TITLE: **SPECIAL PERMIT NO. 1989A**, requested by Sid Dillon, Inc., for authority to amend Special Permit No. 1989 to change the lighting plan for Sid Dillon Automobile Dealership to modify the requirement that all outside lighting shall meet the City of Lincoln Design Standards for parking lots, on property generally located at South 27th Street and Kendra Lane.

RE : **Special Permit No. 1989A**
(Lighting plan - Sid Dillon Auto - S. 27th Street and Kendra Lane)
Resolution No. PC-01035

LINCOLN CITY/LANCASTER COUNTY PLANNING STAFF REPORT

PROJECT #: Special Permit No. 1989A, Tamarin Ridge
PROPOSAL: Amend the lighting plan for Sid Dillon property located at 2627 Kendra Lane.
LOCATION: S. 27th St. and Kendra Lane
LAND AREA: Special permit is 11.25 acres, more or less
Sid Dillon is 8.00 acres, more or less

LIGHTING PLAN
By: Olsson Associates

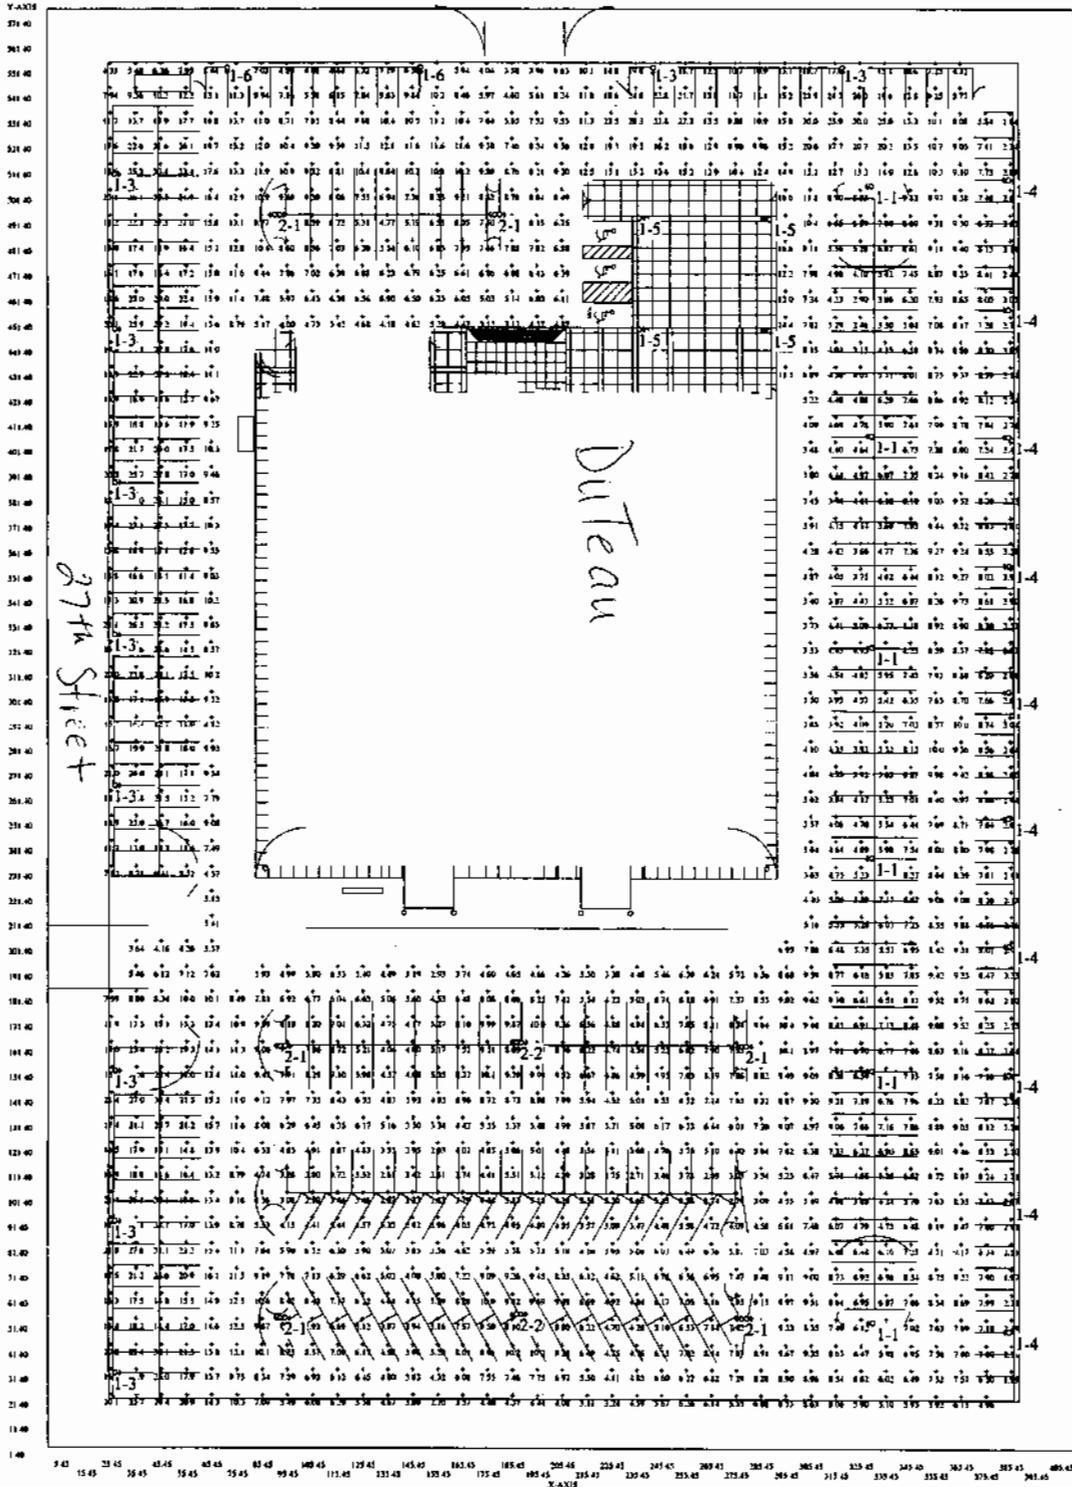
GROUP	MIN	MAX	AVE	AVE/MIN	MAX/MIN
(+)	1.84	31.6	9.20	4.99	17.12

LIGHTING PLAN

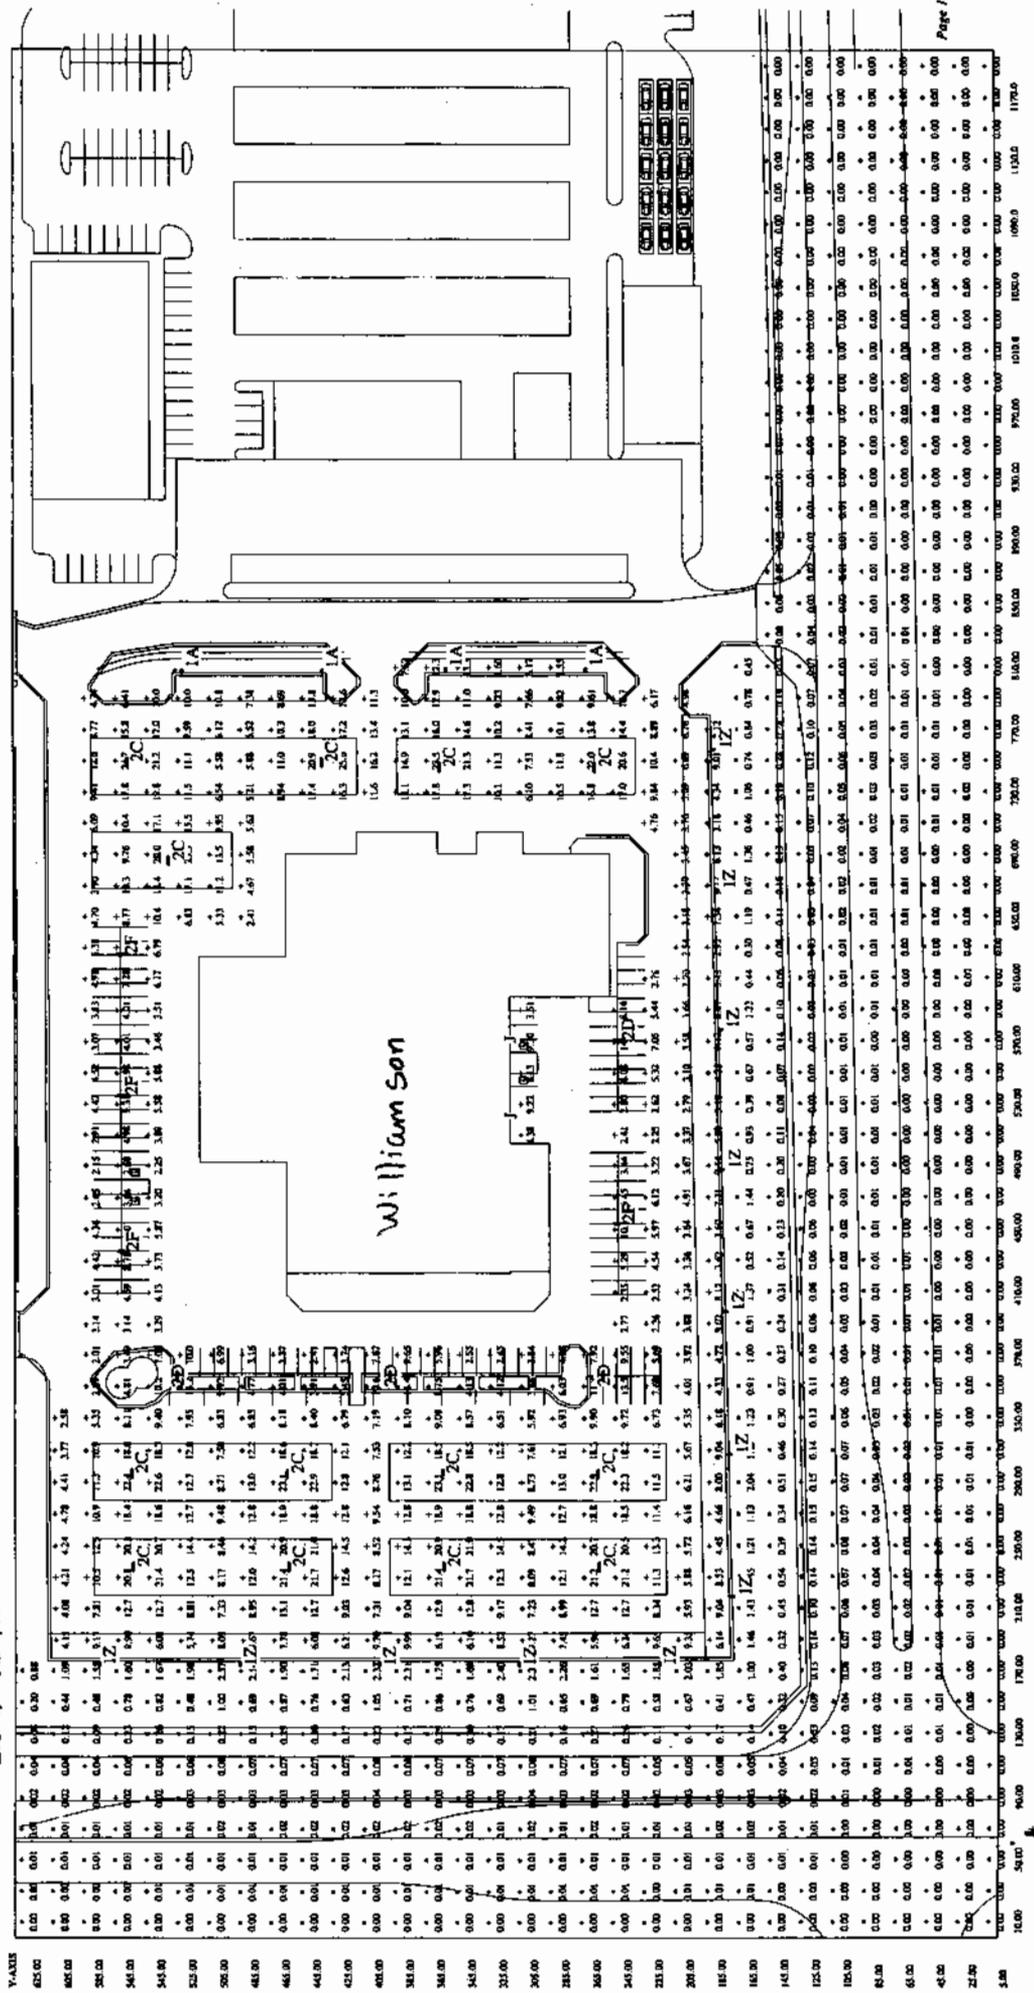
GROUP	MIN	MAX	AVE	AVE/MIN	MAX/MIN
(*) Display Lighting	2.01	25.6	9.56	4.74	12.70
(*) Spill over	0.00	2.37	0.16	N/A	N/A

PL - 4 FC

Display - 10 FC
